## METROPOLITAN GOVERNMENT OF NASHVILLE AND DAVIDSON COUNTY

### STAFF RECOMMENDATION 1206 6<sup>th</sup> Avenue North March 16, 2016

**Application:** New construction—infill; Setback determination  
**District:** Germantown Historic Preservation Zoning Overlay  
**Council District:** 19  
**Map and Parcel Number:** 08209027800  
**Applicant:** John Root, Architect  
**Project Lead:** Melissa Baldock, melissa.baldock@nashville.gov

SITE PLAN

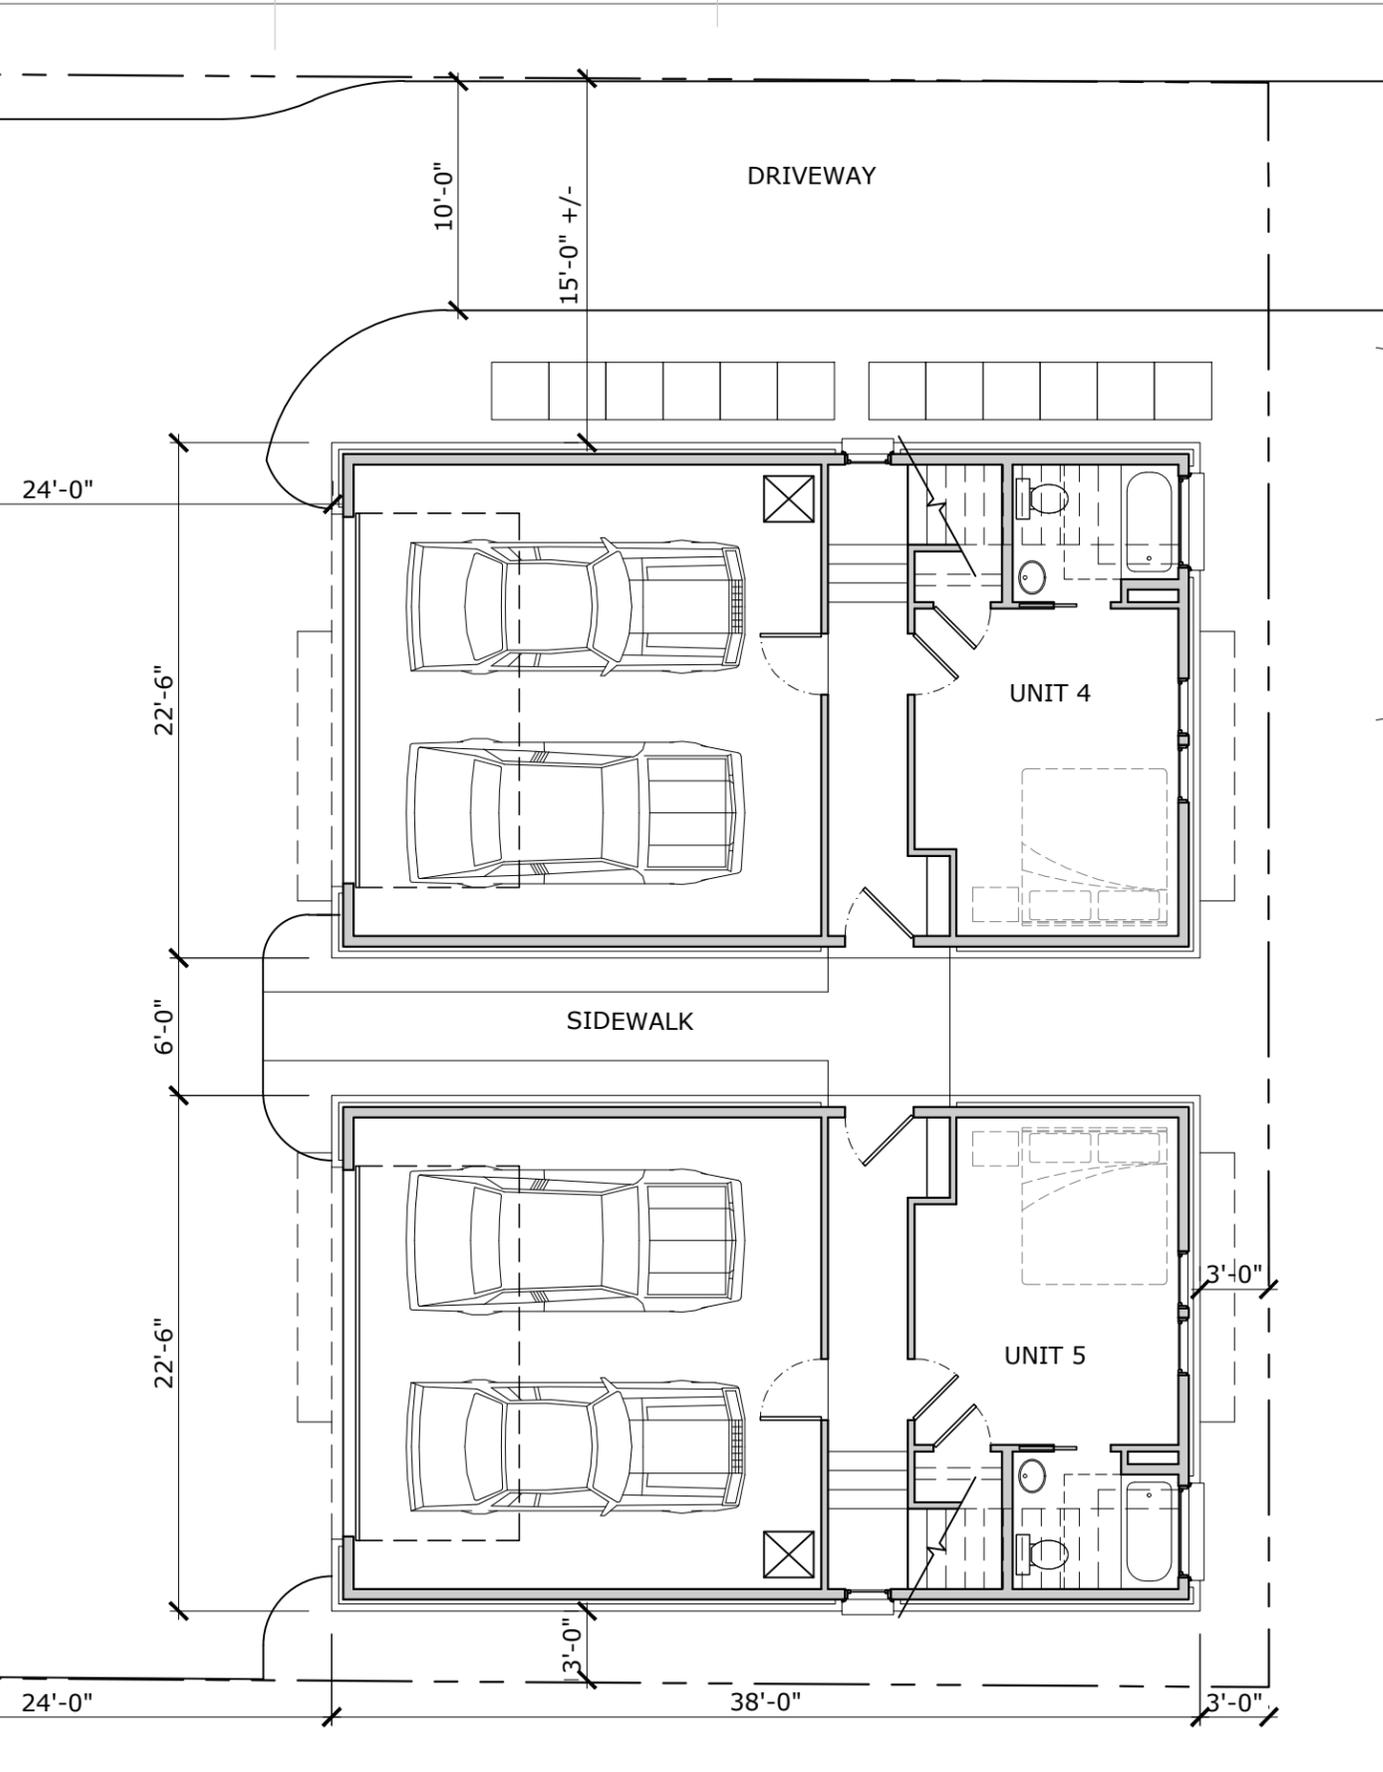
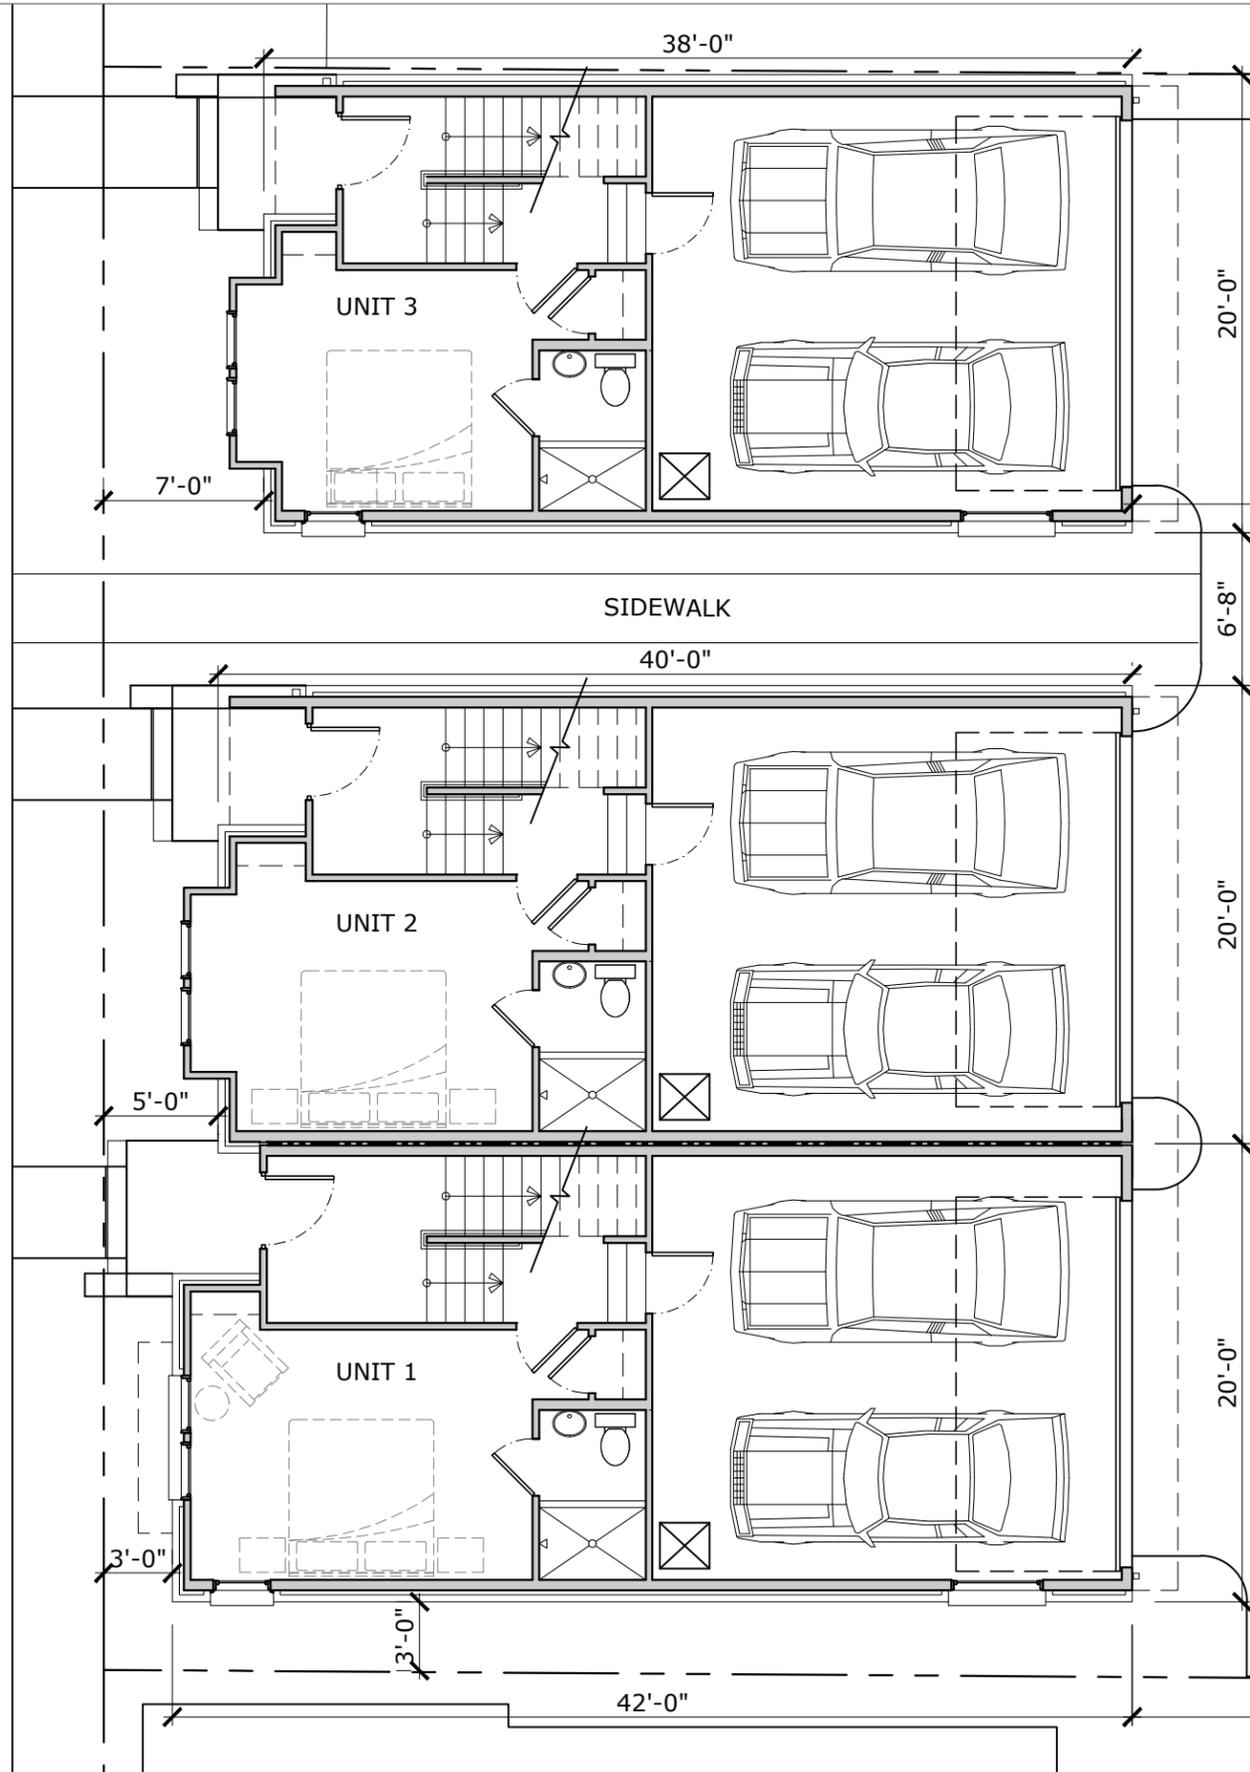
The applicant is proposing to step the front setbacks of the three 6<sup>th</sup> Avenue North townhouses so that the southernmost townhouse is three feet (3') from the front property line, the middle townhouse is five feet (5') from the front property line, and the northernmost townhouse is seven feet (7') from the front property line. These front setbacks make the transition from the c. 2007 multifamily infill at the corner of 6<sup>th</sup> Avenue North and Madison Street, which is two feet (2') from the front property line, to the c. 1999 single family house at 1212 6<sup>th</sup> Avenue North, which is ten feet (10') from the front property line. Staff finds that the proposed front setbacks are appropriate to the context, and recommend approval of the front setback determination.

The proposed townhouses will be three feet (3') from the south/right property line and will sit on the north/left property line. Staff finds these side setbacks to meet both base zoning and the historic context, where multi-family development and even single family houses often sit on or near the side property lines.

The applicant is proposing to construct the two rear townhouses three feet (3') from the rear property line. This would require changing the rear setback from twenty feet (20') to three feet (3'). Staff finds the proposed setback determination appropriate for several reasons. The lot is unusual in that it is shorter than other lots around it and it does not meet the rear alley. The lot is one hundred and ten feet (110') deep, whereas the other midblock lots on this block of 6<sup>th</sup> Avenue North are one hundred and seventy (170') deep. In addition, the rear of the lot abuts the side and rear of the lot situated at the corner of Madison and 6<sup>th</sup> Avenue North. The area that it abuts is the parking and open space area for this development, and therefore the area will likely remain open space for the foreseeable future. The reduced rear setback will not significantly impact the neighboring properties. In addition, reducing the rear setback allows for space for an interior driveway and vehicular access to each of the five units.

Utilities/Mechanical. No location for the mechanicals and utilities were indicated on the site plan, and staff recommends that they be place at the rear or on the townhouse roofs, hidden by the parapet wall.

Fences, walls, and other appurtenances. A walkway between the middle and the northernmost unit is proposed to lead from the sidewalk on 6<sup>th</sup> Avenue North to the interior of the lot. Another sidewalk will be located in between the two rear units. Pavers are indicated in between the driveway and the rear unit number 4, and staff recommends review of the paving material. Staff also recommends approval of the final driveway and interior court yard design. No fencing or walls were indicated on the site

plan, and staff will want to review all fencing, walls, and other appurtenances to ensure they meet Section 5.1 of the design guidelines.

1. Staff approve the final details, dimensions and materials of windows and doors prior to purchase and installation;
2. Staff approve masonry;
3. Staff approve the materials of the pathways and the interior courtyard pavers;
4. The HVAC for the front three townhouses be located at their rear, or on their roofs, hidden by the parapet walls; and
5. Staff approve all appurtenances, including, but not limited to, paving, driveways, fencing, railings, etc.

6TH AVE N EVELATION

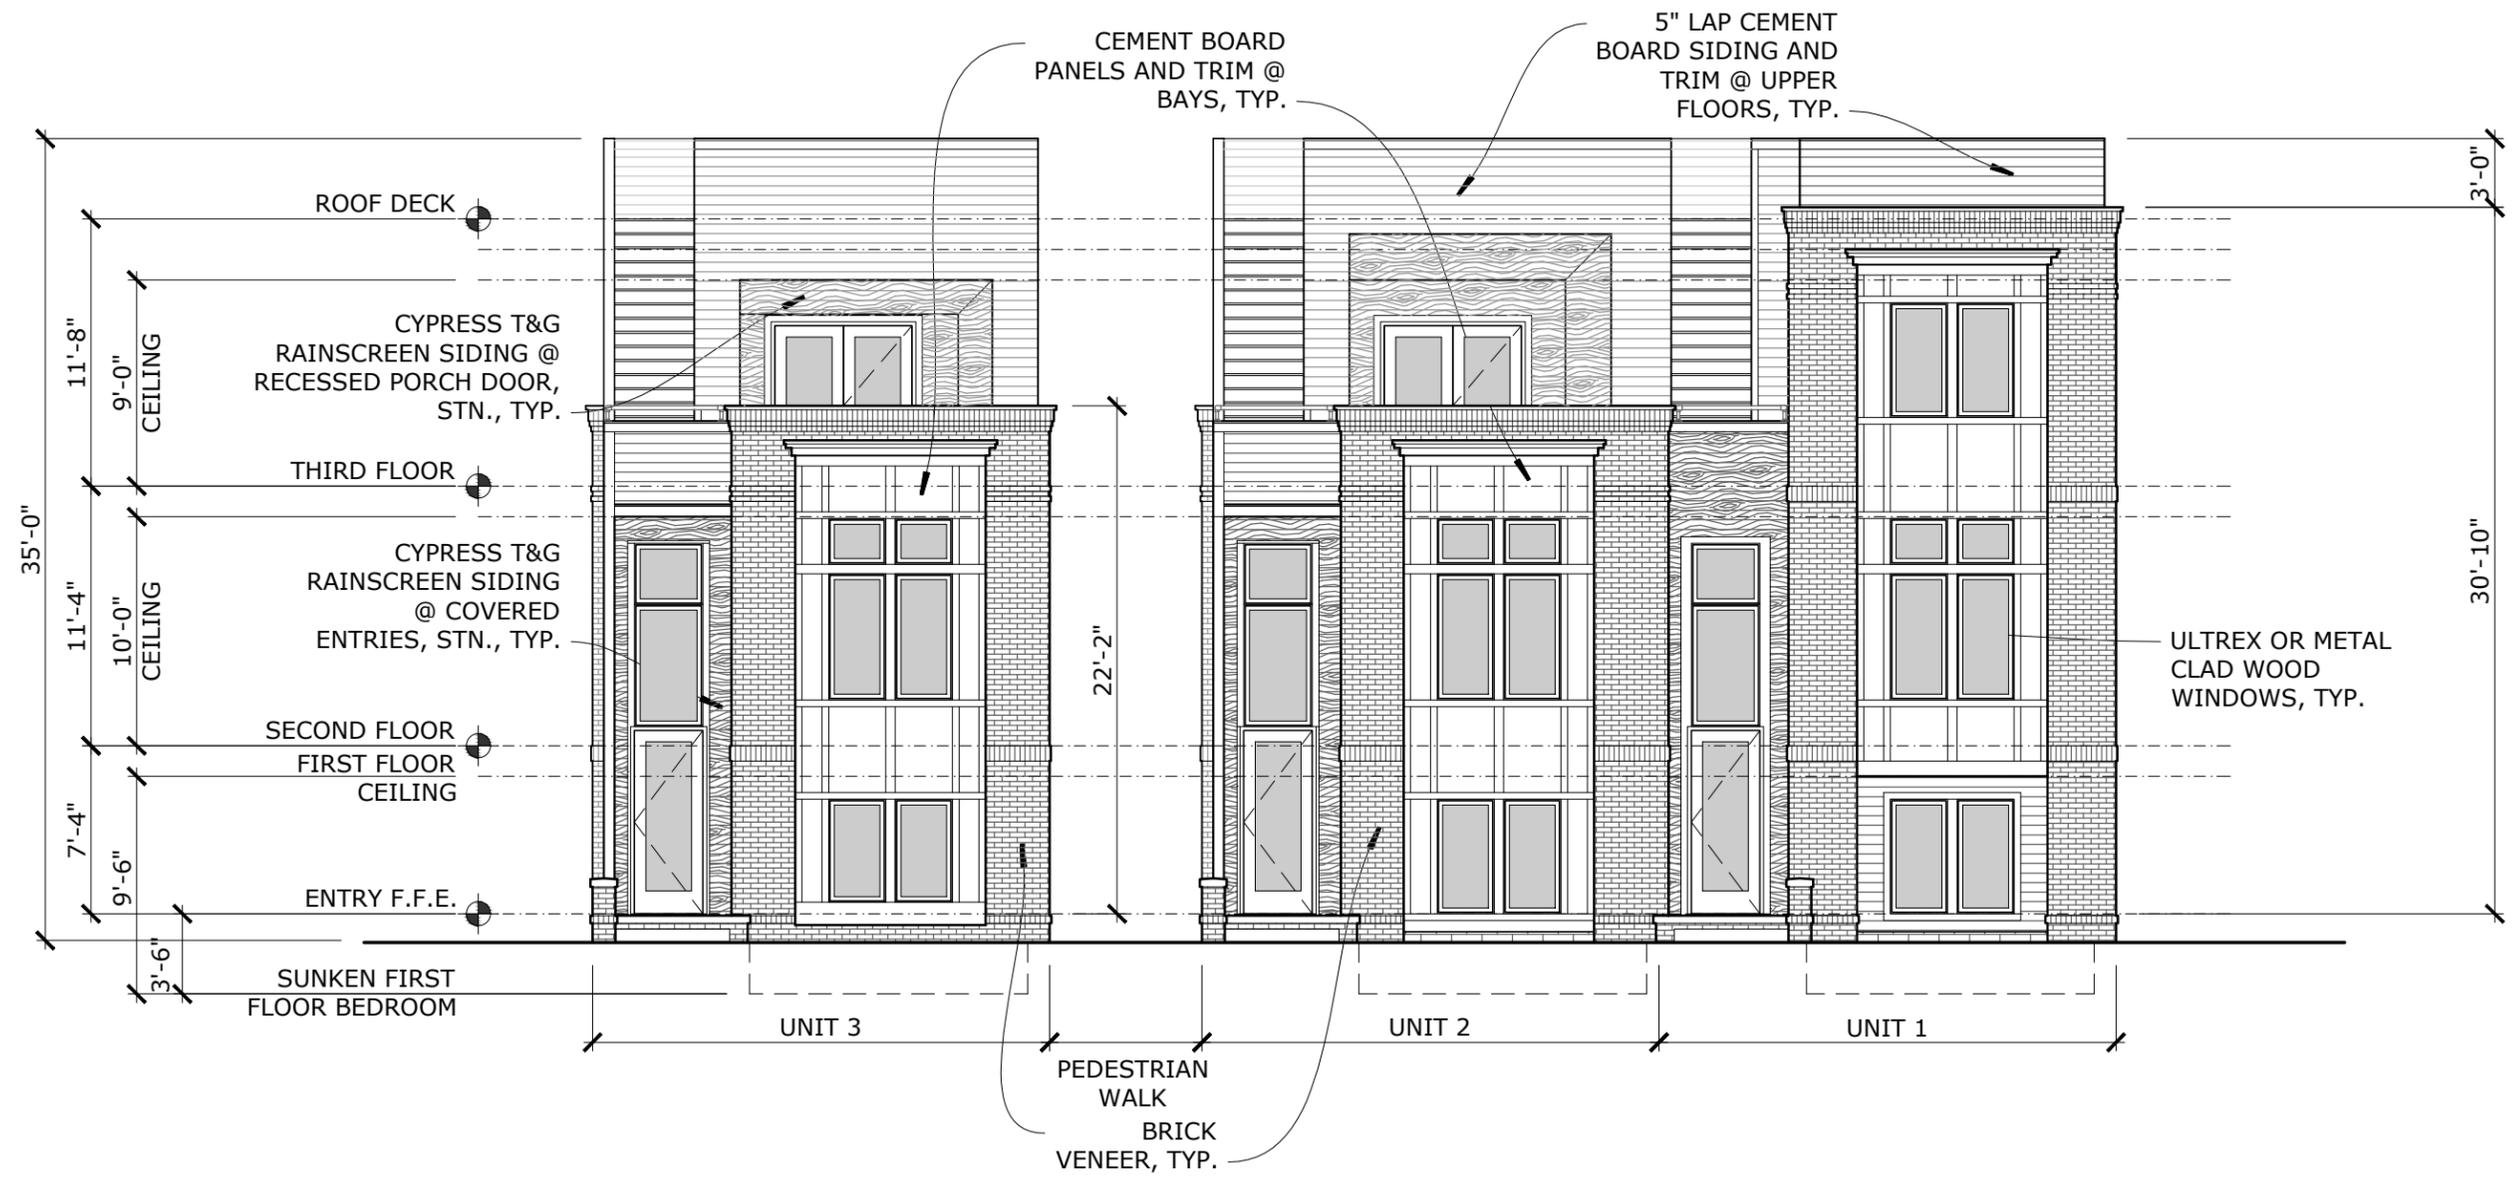
Massing, Scale, and Height. The two southernmost 6<sup>th</sup> Avenue North townhouses are attached, with a total width of forty feet (40'). The third unit will be separated from the other two units by a seven foot (7') wide walkway, and this townhouse will be twenty feet (20') wide. Staff finds that this width meets the historic context, as the site serves as a transition from the multi-family development at the corner to the smaller-scale single family houses on the interior of the lot and the break between the units allows for pedestrian access to the rear units. The historic houses on the block have widths that range from twenty-one feet to forty-six feet (21'-46'), and staff therefore finds that the proposed widths are appropriate. The three front townhouses will be between forty and forty-two feet deep (40'-42') deep.

The southernmost townhouse unit will be three stories in height, but the other two townhouses will be two stories tall, with a recessed third story. All three townhouses will have a maximum height of thirty-five feet (35'). Staff finds the three story townhouse to be appropriate because the c. 2007 infill next door is three and a half stories in height and approximately forty feet (40') tall. The step-backed upper levels will help the development transition from the taller infill on the corner to the smaller-scale historic houses on the interior of the block.

The two other townhouses will be two stories and approximately twenty-three feet (23') tall at the front. Third stories plus a roof deck are added, recessed from the front wall of the townhouses. The middle townhouse's third story is recessed between five feet, six inches and seven feet, six inches (5'6"-7'6") from the front wall of the house, and the northernmost townhouse's third story is recessed between seven and nine feet (7'-9') from the front wall of the house.

Foundation. The proposed foundations for the three front townhouses are approximately one foot (1') tall. The foundations will be brick and will be separated from the wall above with a brick soldier course. The foundations for the two rear townhouses will also be brick with a soldier course, but will be taller at approximately three feet tall (3'). Staff finds this to be appropriate since these foundations will be at most minimally visible from the street. Staff finds that the proposed foundations meet Section 2.3. of the design guidelines.

Materials. The primary façade material will be brick, and staff recommends approval of a brick sample. Five inch cement fiber board lap siding, cement fiber board panels and battens, and cypress rainscreen siding will be used as accent materials. The windows will be Marvin Integrity windows or other metal clad windows, and staff recommends review and approval of the final window and door selections prior to purchase and installation. The entryway step and floor will be concrete. The balcony handrails will be steel. Staff recommends approval of the material of the pathways and interior courtyard pavers. With the aforementioned staff approvals, staff finds that the proposed materials meet Section 2.4 of the design guidelines.

Windows and Doors. The window and door openings are all appropriately recessed for a brick structure. The proposed infill's windows are generally twice as tall as they are wide, thereby meeting the historic proportion of window openings. The side facades of the front townhouses will have few window openings on them, which can be typical of townhouse development, particularly when a façade sits on or near the property line. The rear townhouse fenestration pattern will not be highly visible from the street. Staff finds that the proposed windows and doors meet Sections 2.5. and 2.6. of the design guidelines.

Porches and Entrances. The three 6<sup>th</sup> Avenue townhouses will have entrances off of 6<sup>th</sup> Avenue North, which is appropriate. The entries will be recessed, and will be located behind low stoops, which is appropriate for a townhouse design. The rear townhouses will have entries on the side, which staff finds to be acceptable since these entries will not be visible from the street. Staff finds that the proposed stoops and entrances meet Section 2.6 of the design guidelines.
